UNITED STATES PATENT AND TRADEMARK OFFICE

10/527,462

DATE MAILED: 10/27/2006

| Office Action Summary | Application No. 10/527,462 | Applicant(s) VAN LOON ET AL. | |

FIG. 5

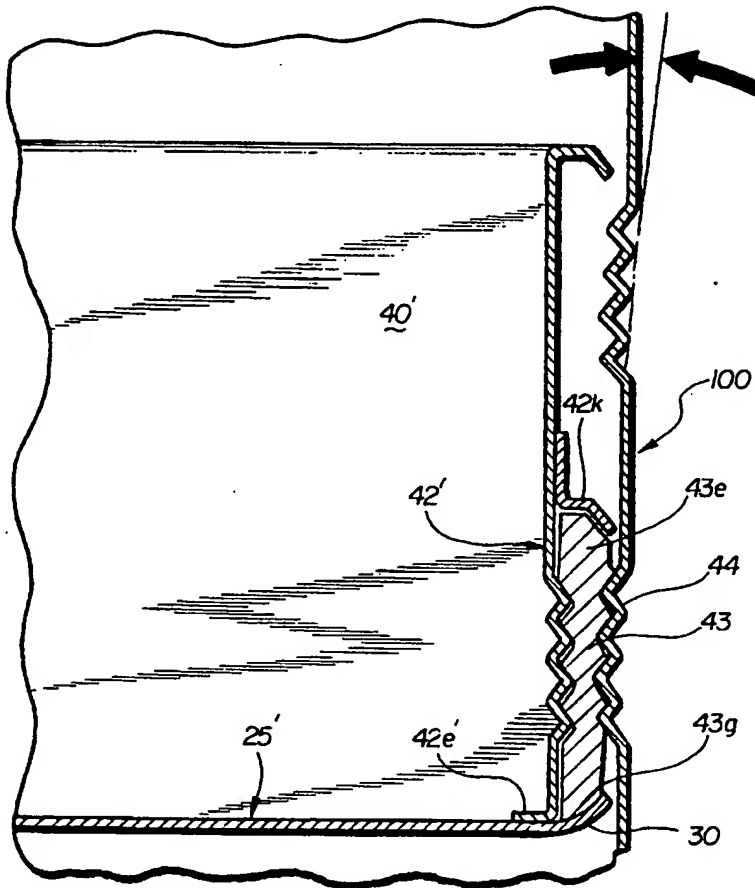
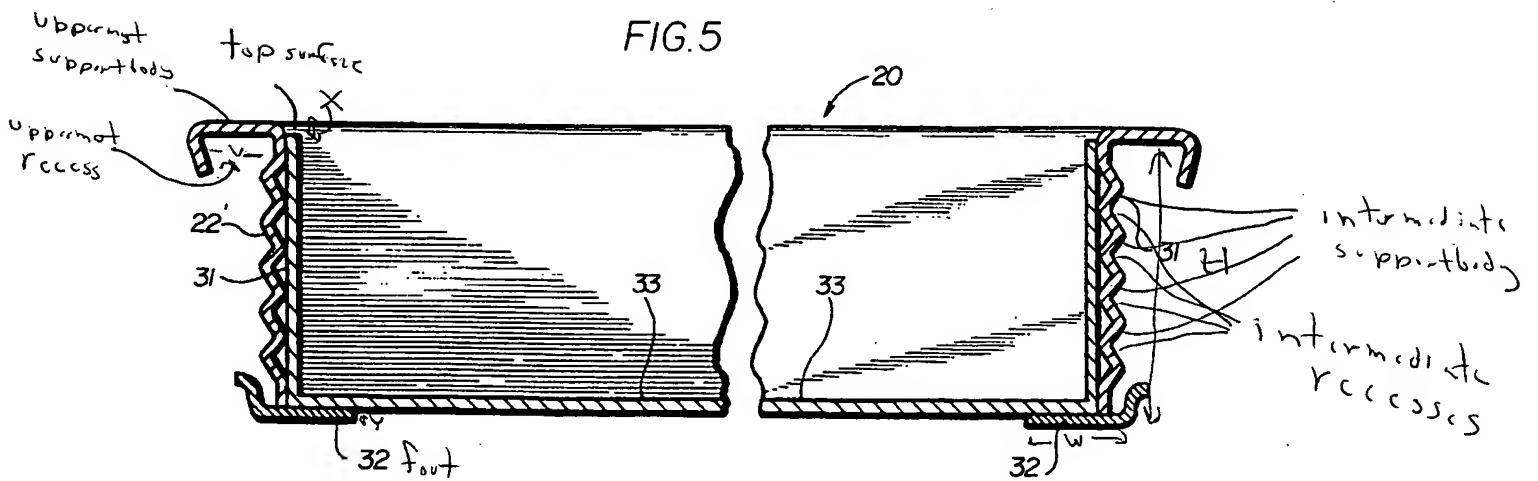
Claims 1, 2, 2/5, 6, 7 and 14-16 are rejected under 35 U.S.C. 102(b) as anticipated by or, in the alternative, under 35 U.S.C. 103(a) as obvious over Krivec (5,549,377). Krivec teaches a drawer (Fig. 5; see Attachment A) which is part of a wheeled cabinet (see Fig. 1) comprising: a bottom surface (33), two side walls (22',31) with a height of H and a horizontal top surface (see Attachment A). The side walls have an uppermost recess that extends the entire side wall, is open toward the outside of the drawer and is delimited from above by an uppermost support body (see Attachment A). The uppermost recesses, viewed in the vertical direction, are a recess distance X away from the top surface and the outside of the uppermost support bodies, view in the horizontal direction, have an external support body spacing V (see Attachment A). A supporting foot (32) extends along the side walls and extends below the bottom surface to a support depth Y (see Attachment A) which appears to be greater than recess distance X. The foot has an internal spacing W which appears to be greater than the spacing V. It should be noted that even if the "greater than" distances discussed above were found not to be accurate (drawings are not necessarily to scale and the compared dimensions are close in size), it would have been obvious to

Attachment B

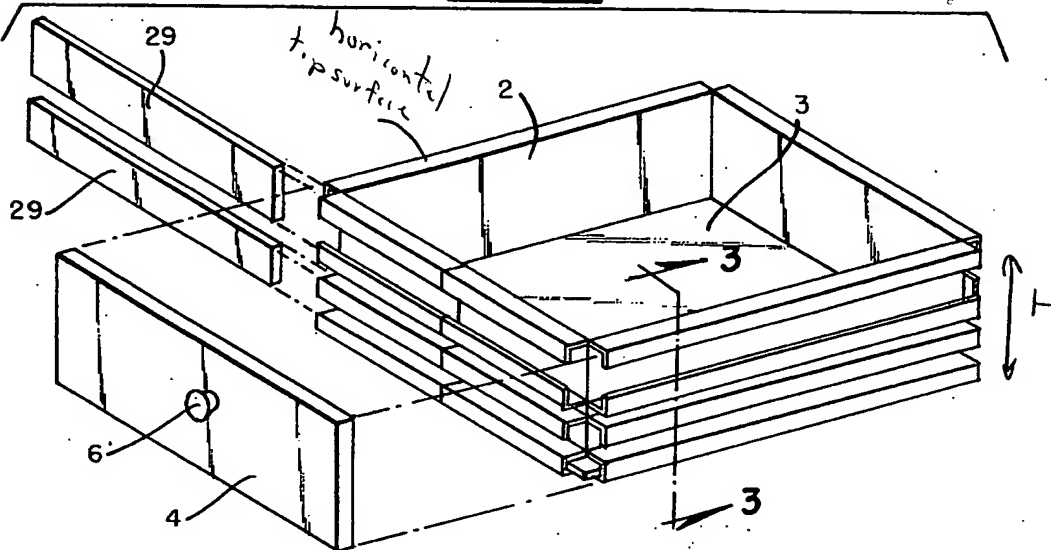
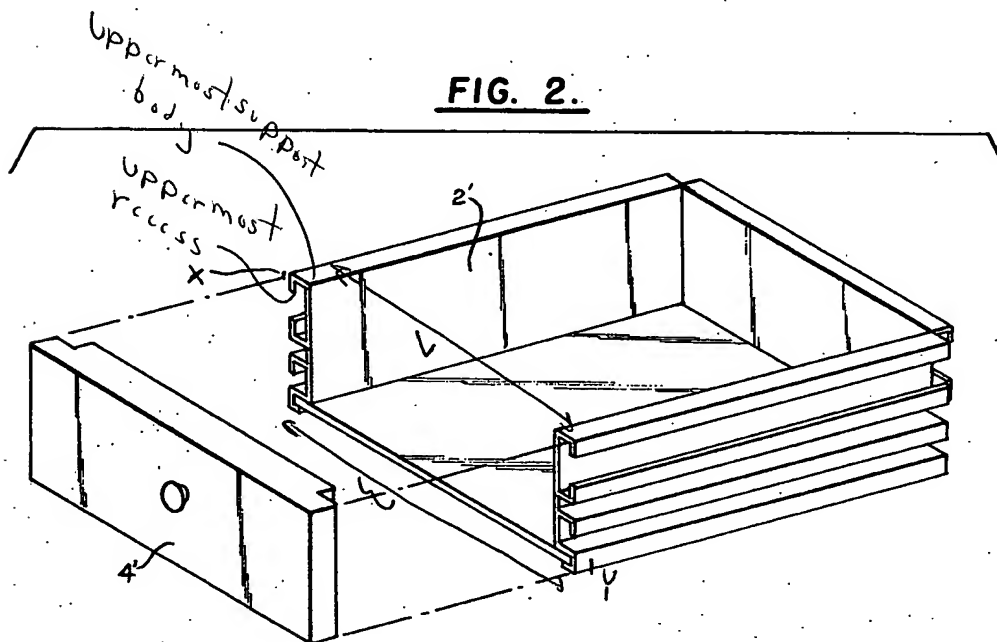
Claims 1, 2, 2/5, 6, 7, and 14-16 are rejected under 35 U.S.C. 102(b) as anticipated by or, in the alternative, under 35 U.S.C. 103(a) as obvious over Ullman Jr. (3,726,579). Ullman teaches a drawer (Figs. 1 and 2; see Attachment B) comprising a bottom surface (3), two side walls (2) with a height of H and a horizontal top surface (see Attachment B). The side walls have an uppermost recess that extends the entire side wall, is open toward the outside of the drawer and is delimited from above by an uppermost support body (see Attachment B). The uppermost recesses, viewed in the vertical direction, are a recess distance X away from the top surface and the outside of the uppermost support bodies, view in the horizontal direction, have an external support body spacing V (see Attachment B). A supporting foot (9a) extends along the side walls and extends

below the bottom surface to a support depth Y (see Attachment B) which appears to be greater than recess distance X. The foot has an internal spacing W which appears to be greater than the spacing V (see Fig. 3). It should be noted that even if the "greater than" distances discussed above were found not to be accurate (drawings are not necessarily to scale and the compared dimensions are close in size), it would have been obvious to dimension the drawer components wherein these limitations would be met. Furthermore, the equation found in claim 2 would inherently be provided for by Ullman. For claim 6, it should be noted that product by process limitations are given no weight in a claim.
